CITY OF ALBUQUERQUE

January 2, 2024

Re: 2900 Central
2900 Central Ave. SE
Traffic Circulation Layout
Engineer's Stamp 12-01-23 (K16-D009A)

TCL2

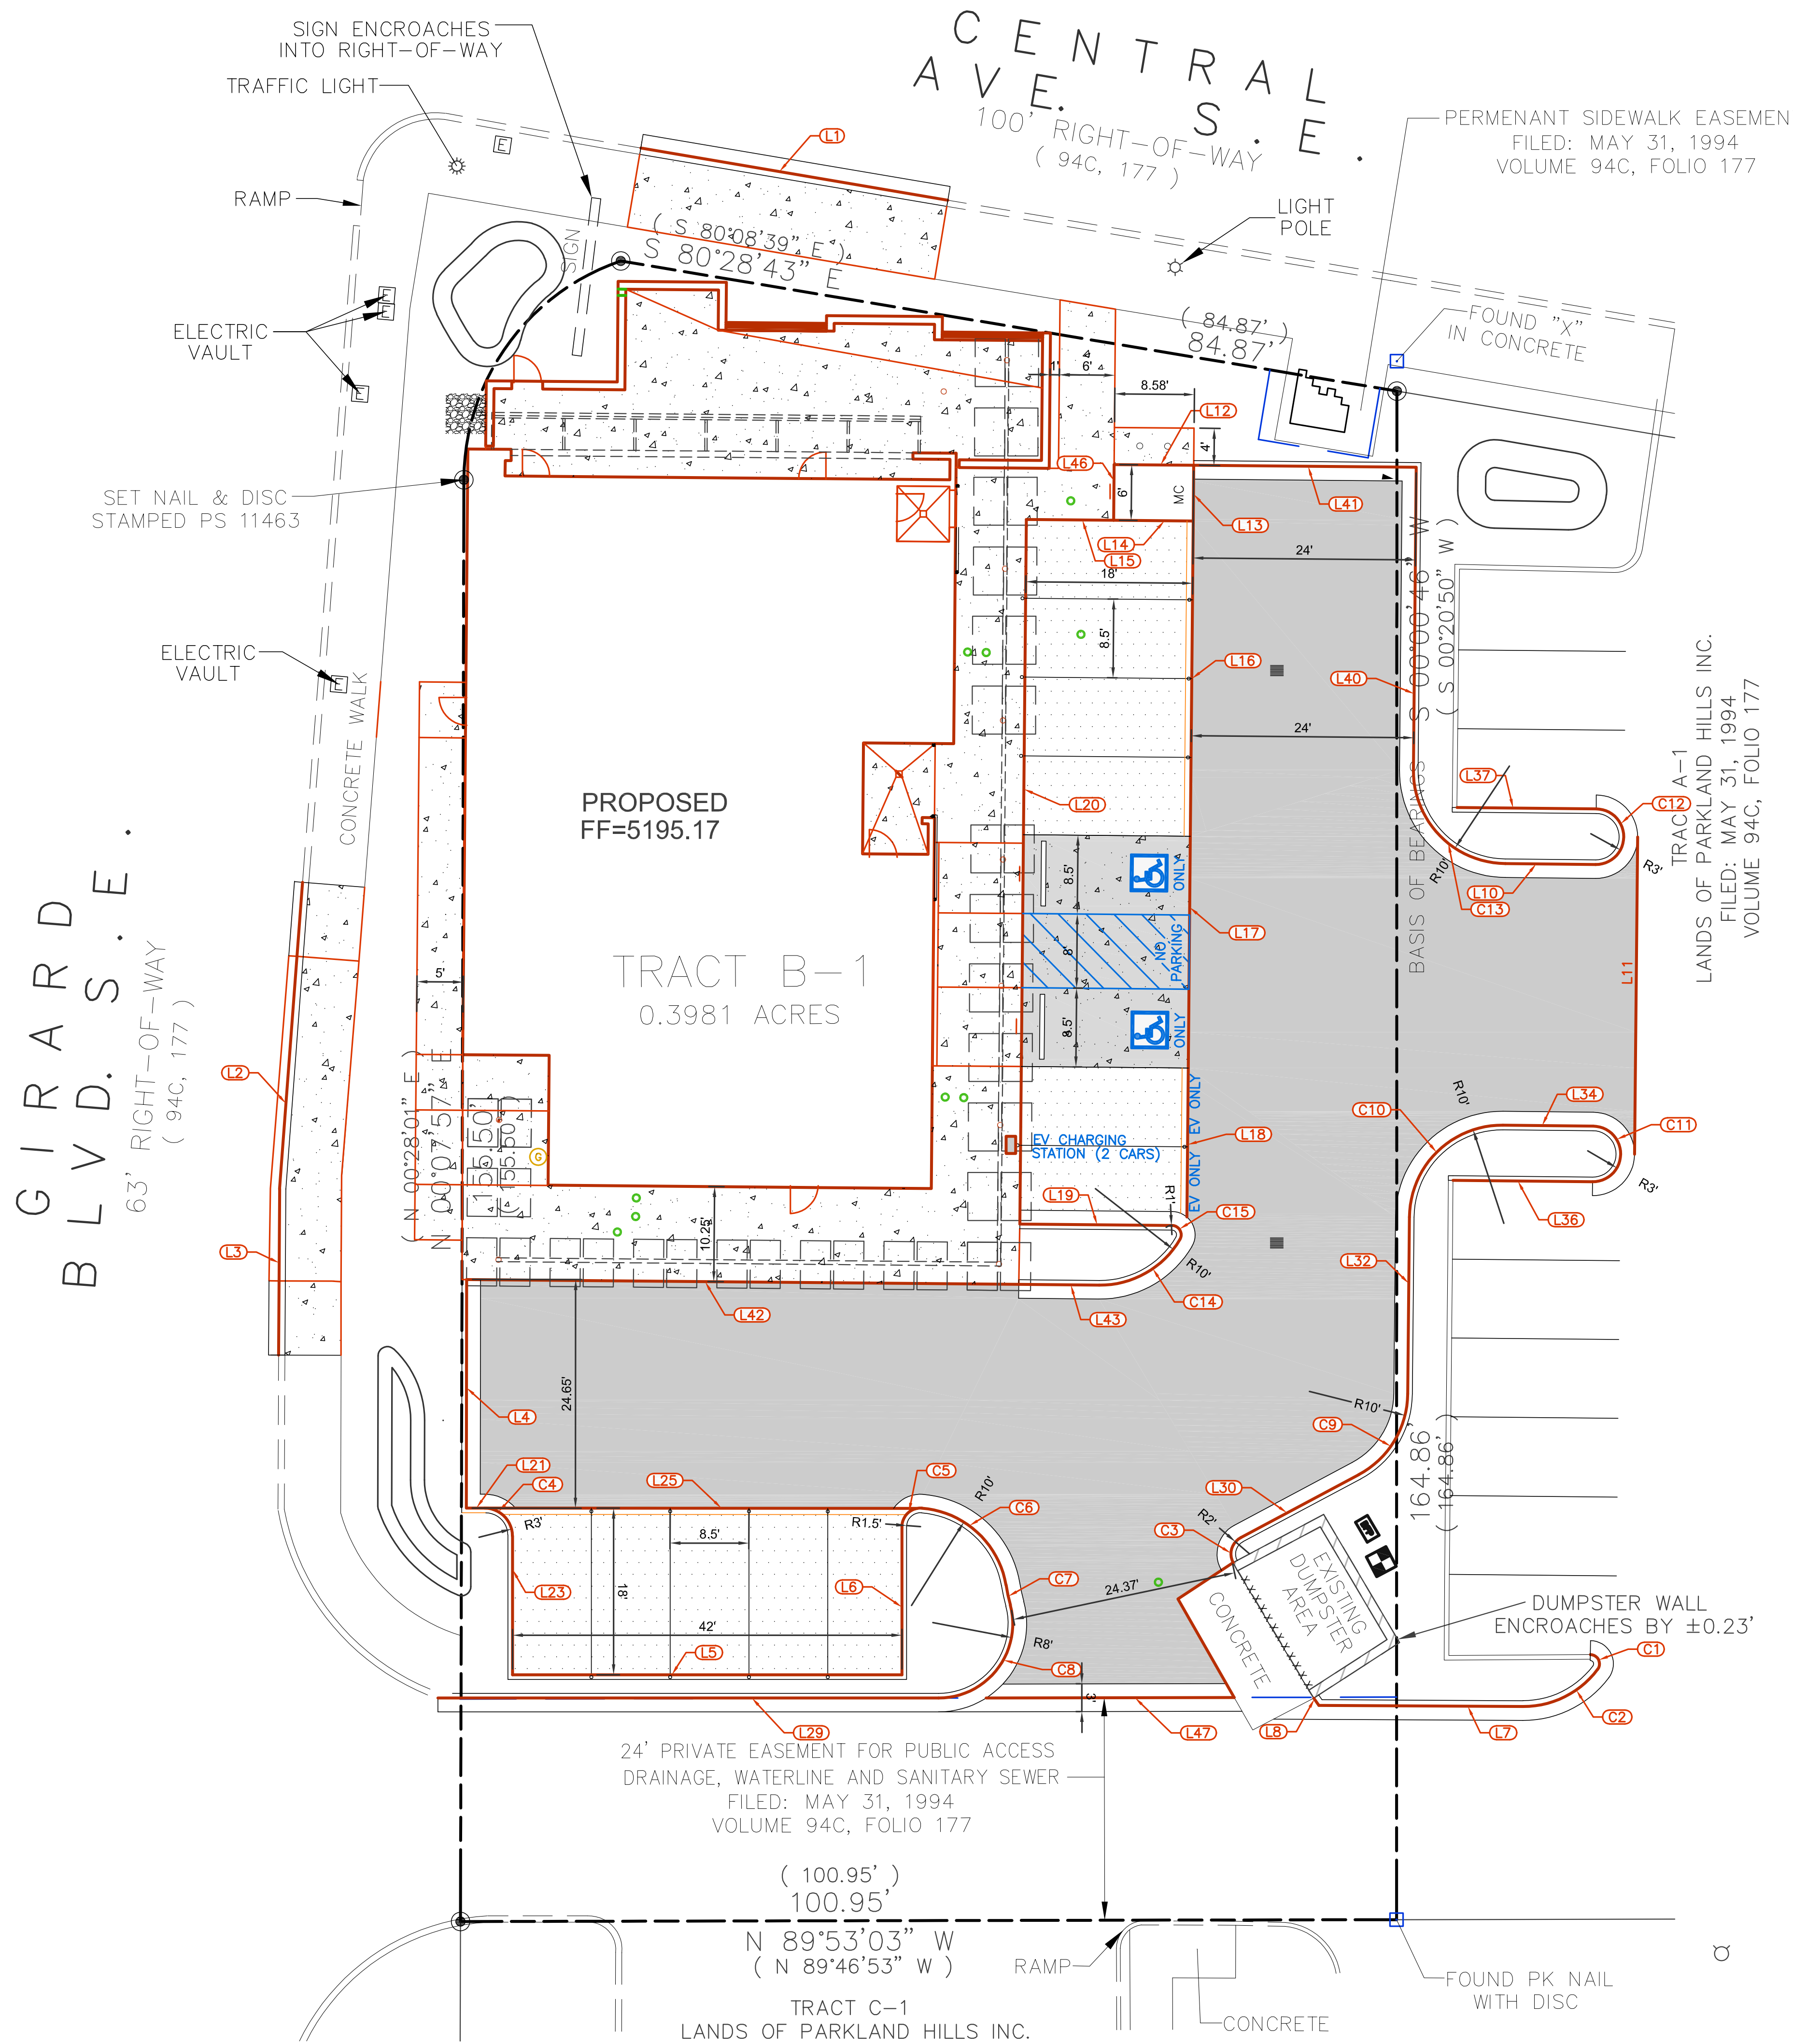
7. Please remove any non related transportation details from sheet C502, such as details E1,2,3,D5, and A5.
8. It appears there are two signs encroaching into right of way, either remove them or a revocable permit is required.

TCL1

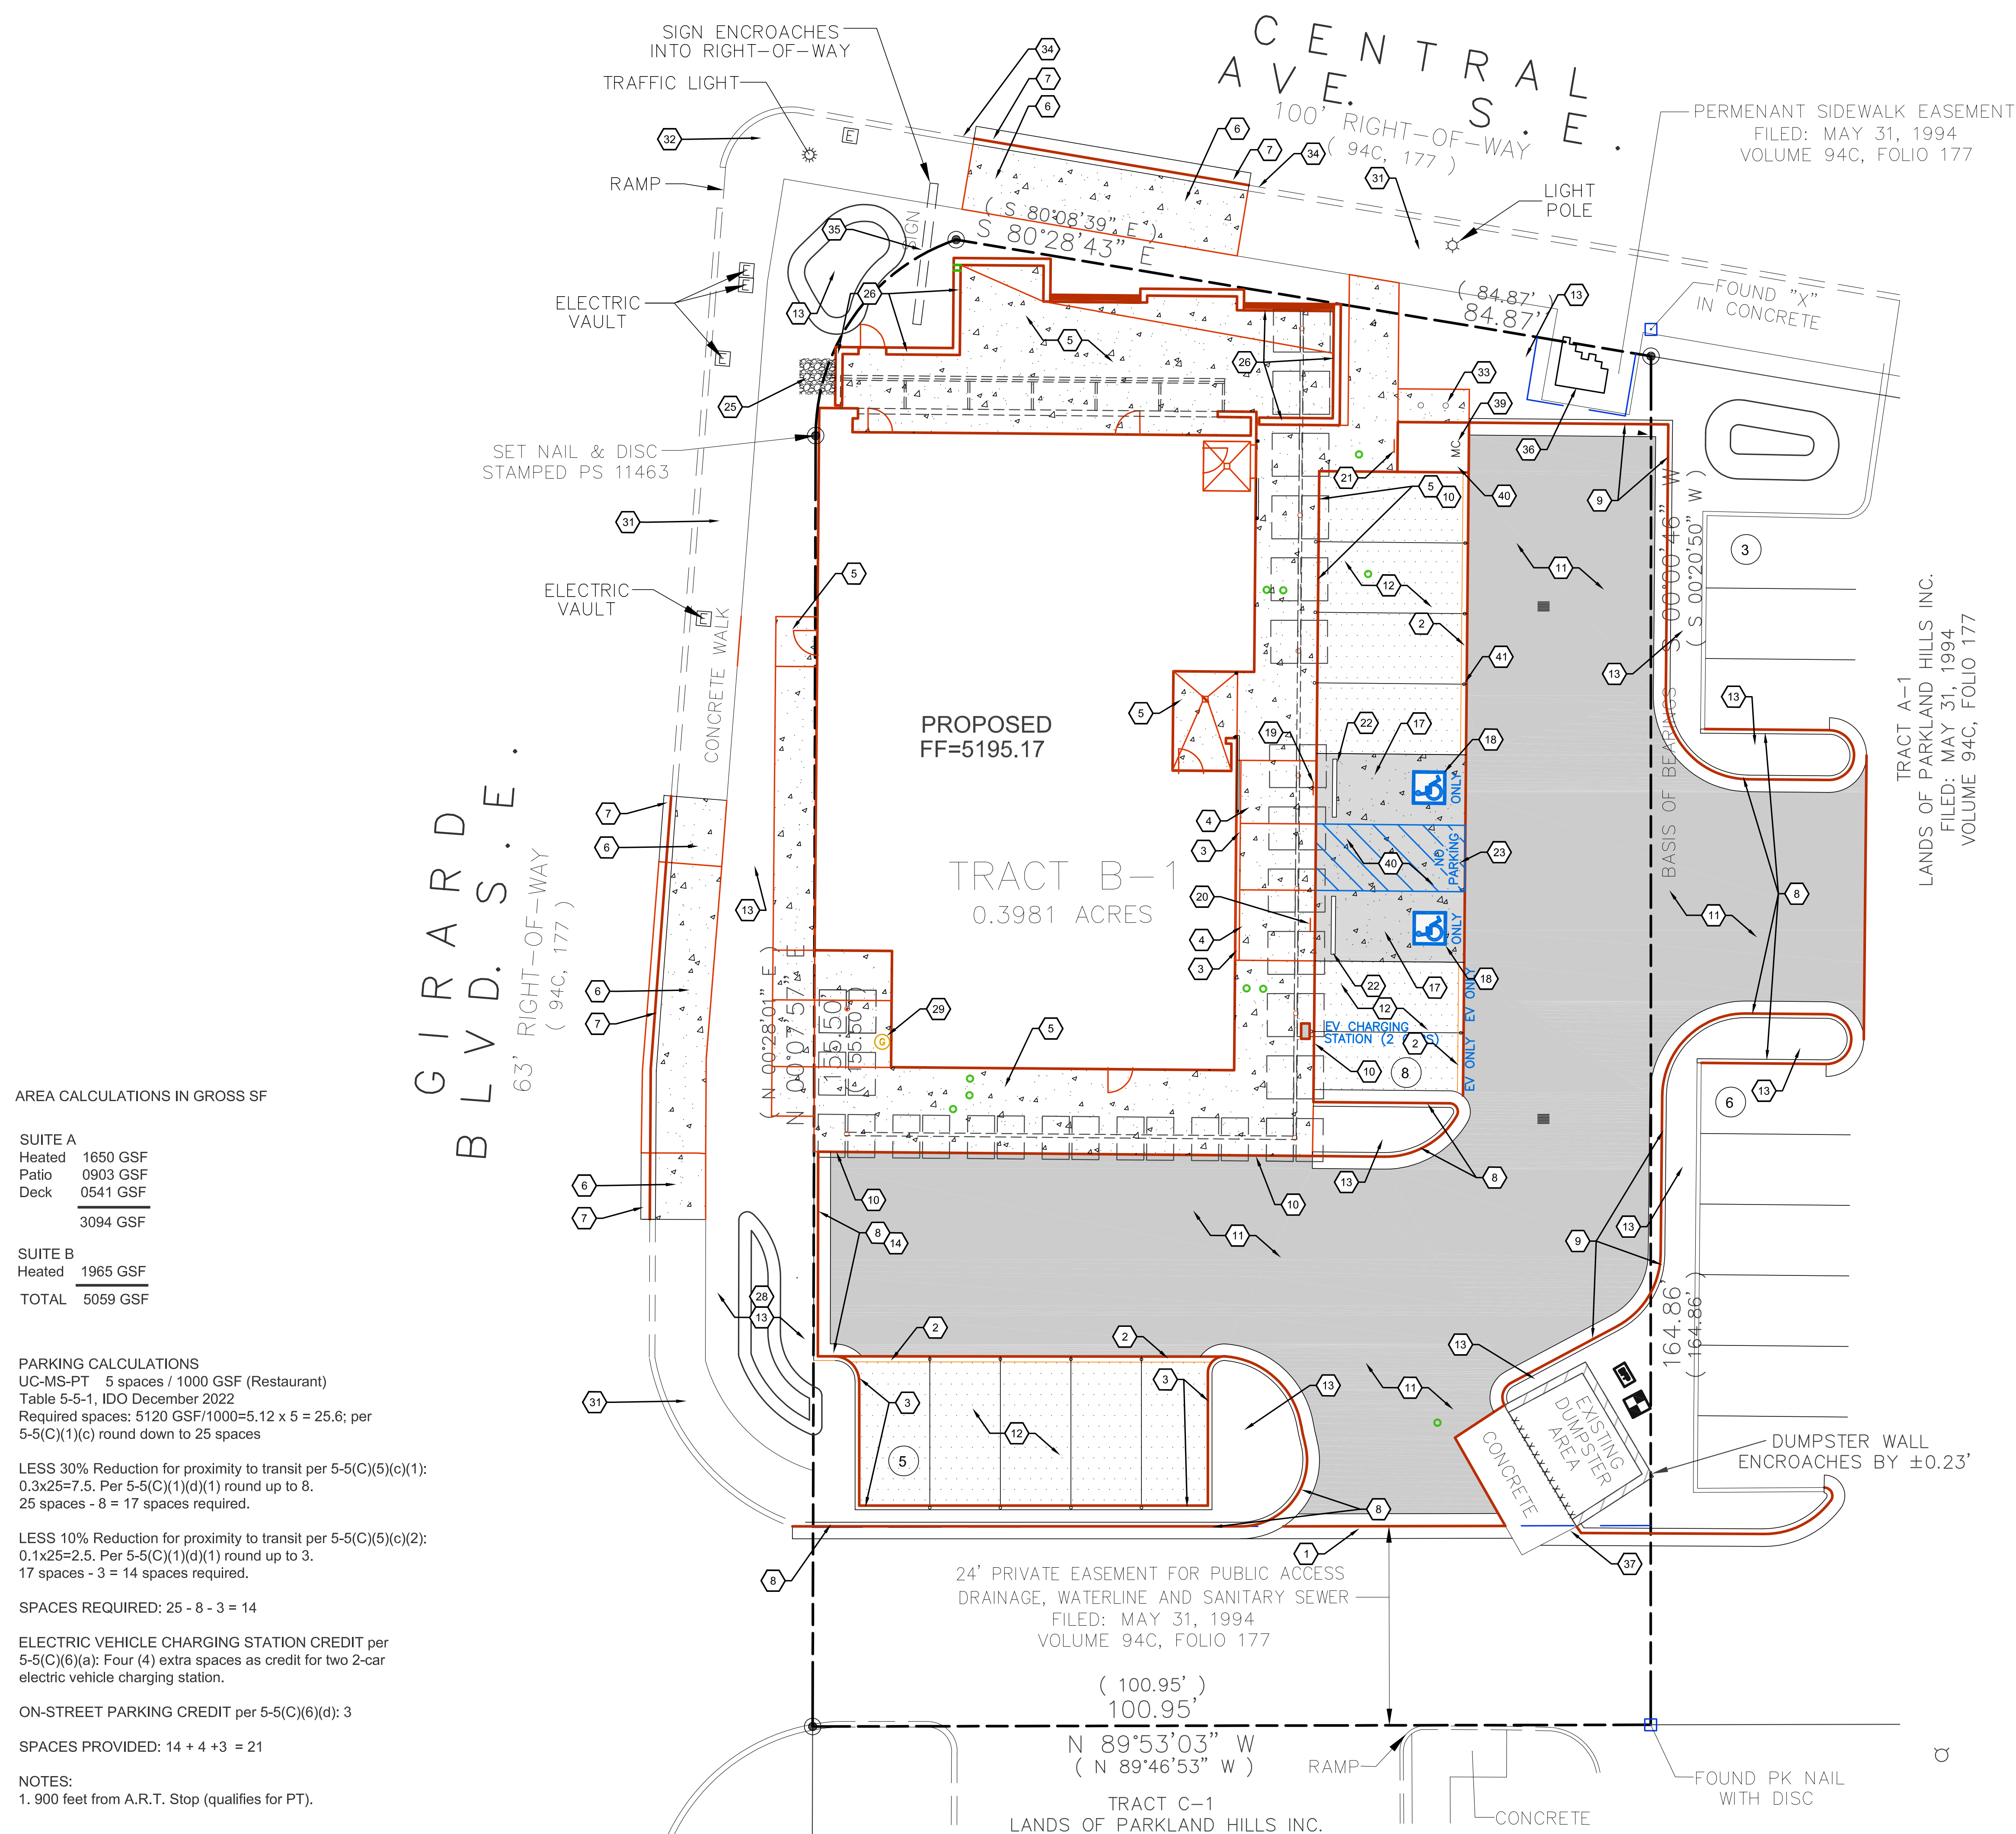
1. Please show a vicinity map showing the location of the development in relation to streets and well-known landmarks.
2. Identify all existing access easements and rights of way width dimensions.
3. Please provide shared parking agreement with east side property.
4. Due to proposed new site access and removing some parking spaces from the east side property, please submit shared access agreement and parking calculation. This documentation should demonstrate that the remaining parking spaces on the east property still meet the required standard. Also, please provide the width for this access.

5. The ADA accessible parking sign must have the required language per 66-7-352.4C NMSA 1978 **"Violators Are Subject to a Fine and/or Towing."** Please call out detail and location of signs.
6. Show on the site plan this sidewalk width.

9. Refuse vehicle maneuvering shall be contained on-site. The refuse vehicle shall not back into the public right of way.; provide a copy of refuse approval.

10. Provide a copy of Fire Marshal approval.
11. Show the clear sight triangle and add the following note to the plan: "Landscaping and signage will not interfere with clear sight requirements. Therefore, signs, walls, trees, and shrubbery between 3 and 8 feet tall (as measured from the gutter pan) will not be acceptable in the clear sight triangle.

12. Add a note stating "All broken or cracked sidewalk must be replaced with sidewalk and curb & gutter." A build note must be provided referring to the appropriate City Standard drawing.
